METROPOLITAN DEVELOPMENT COMMISSION

Case Number: 2025-CPL-805/ 2025-CVR-805

Request: 2025-CPL-805 (Amended)
Approval of a Subdivision Plat to be known as Speer's Camby Retreat, dividing 6.686 acres into three lots.

Staff Reviewer: Desire Irakoze, Principal Planner II

Figure 2 Proposed Plat

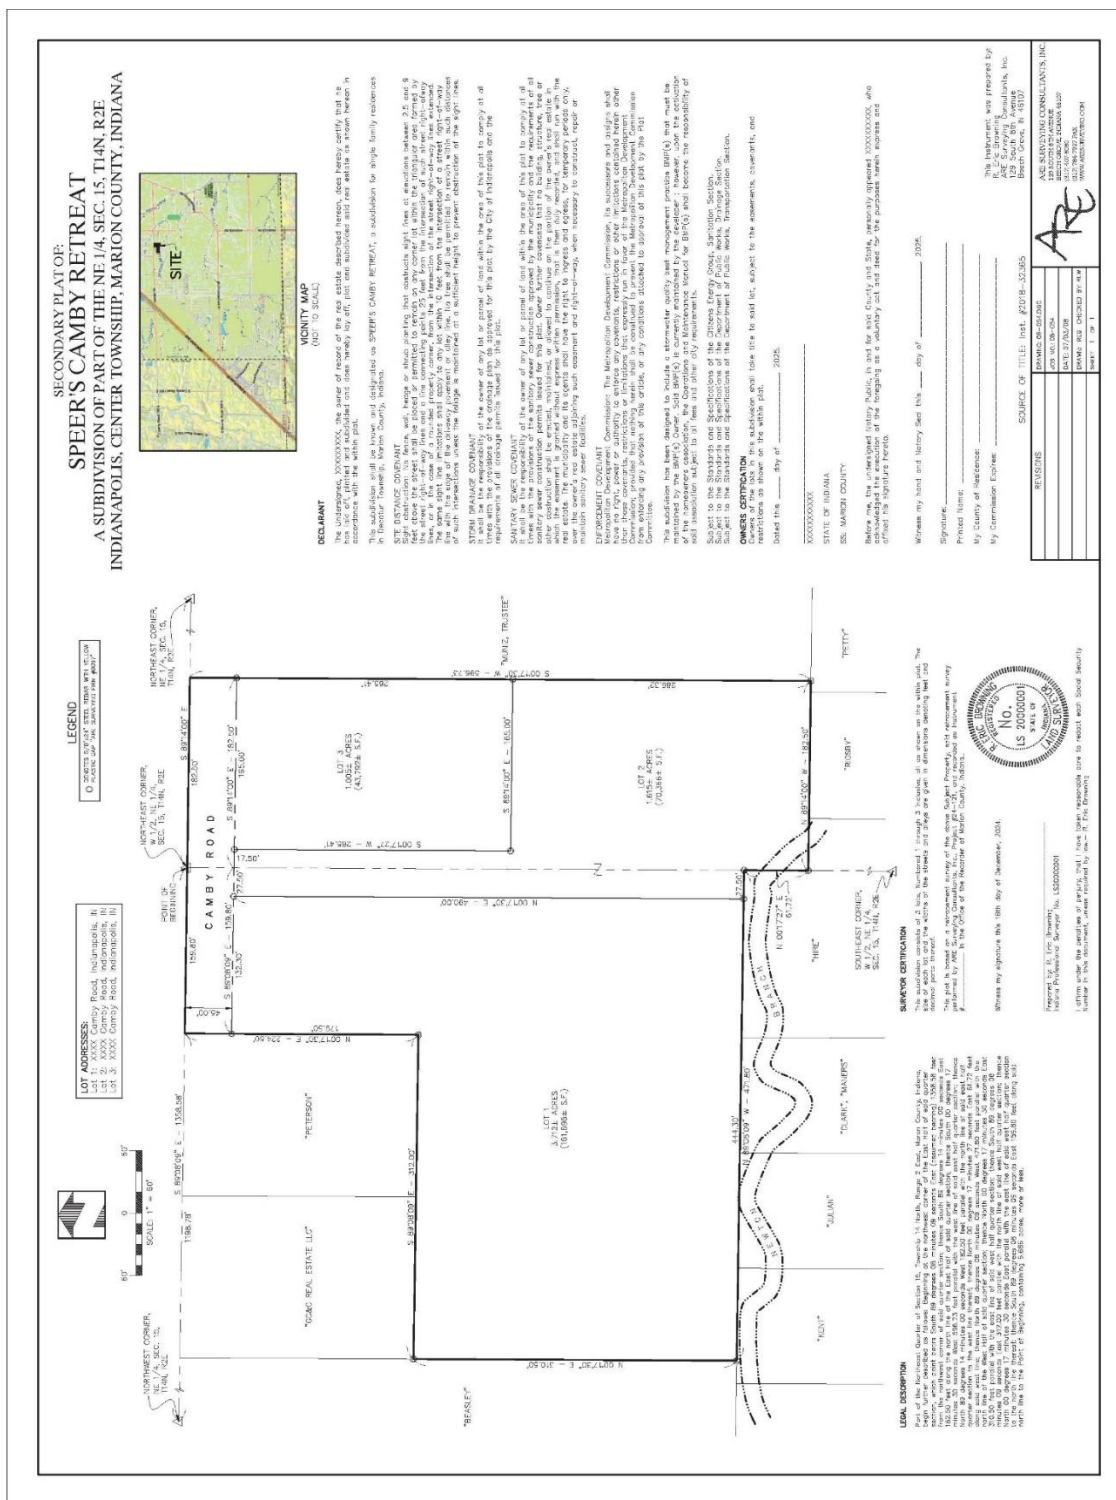
1. **Lot Width (Table 742-103-5):**
Relief from the 70-foot minimum lot width requirement for **Lot Two** only. Lots One and Three comply. Staff notes that the proposed lot width at the building setback line for Lot Two would be approximately **210 feet**, which exceeds the required minimum when measured at the buildable area.

Staff **recommends approval** of the variance of Lot Width; the property will have an average lot width that exceeds the 70 ft. lot width requirement. Lot width is measured at the building setback line. If we measure the lot with at the proposed building line for lot 2 it would have a lot width of 210 ft.

Because there was not opposition to the lot width and to permit on-site septic systems, your Hearing Examiner granted those variance requests. In your Hearing Examiner's opinion, sidewalks are integral to a safe, walkable neighborhood, and the variance to provide for future construction of a freestanding building without installation of frontage sidewalks was denied. Your Hearing Examiner also approved the plat with the condition that the sidewalk waiver request be denied.
